Airport Land Use Commission

**RE: ALUC Consistency determination for a Commercial office building,
located within the Peery Park Specific Plan area at 675 Almanor Avenue.**

675 Almanor

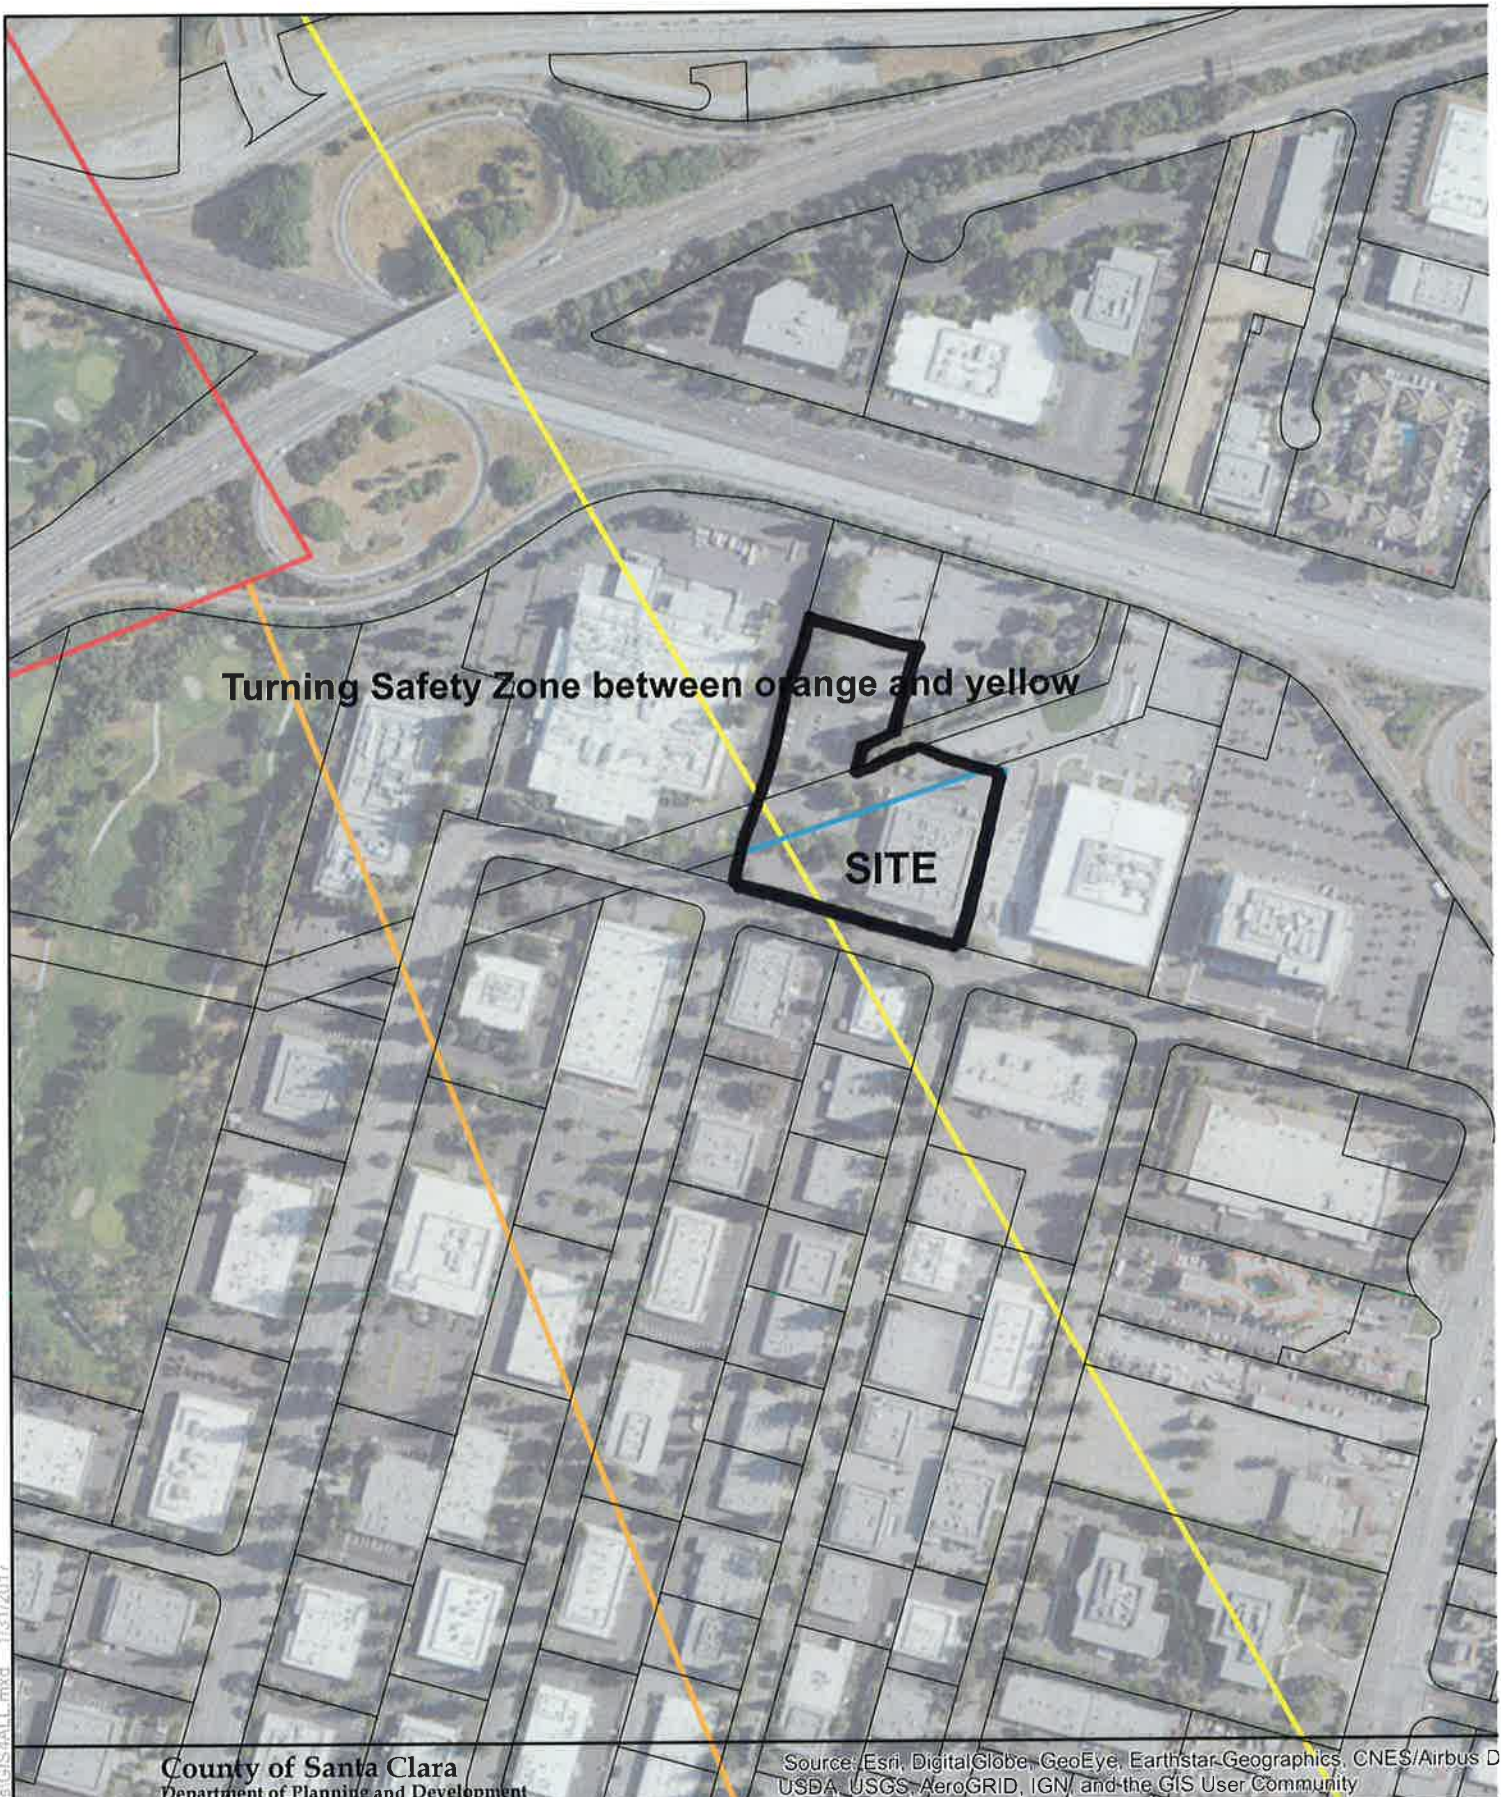
The project site is located within the Airport Influence Area (AIA) of Moffett Federal Airfield. The site is located outside of all noise contours, but is located partially within the southwesterly Turning Safety Zone (TSZ). Also, structures are proposed approximately beneath the 182 Mean Sea Level (MSL) FAA Part 77 Surface, which is used by the ALUC as a height restriction boundary.

The project has been designed to avoid any structures within the TSZ and has parking and landscaping proposed within this area.
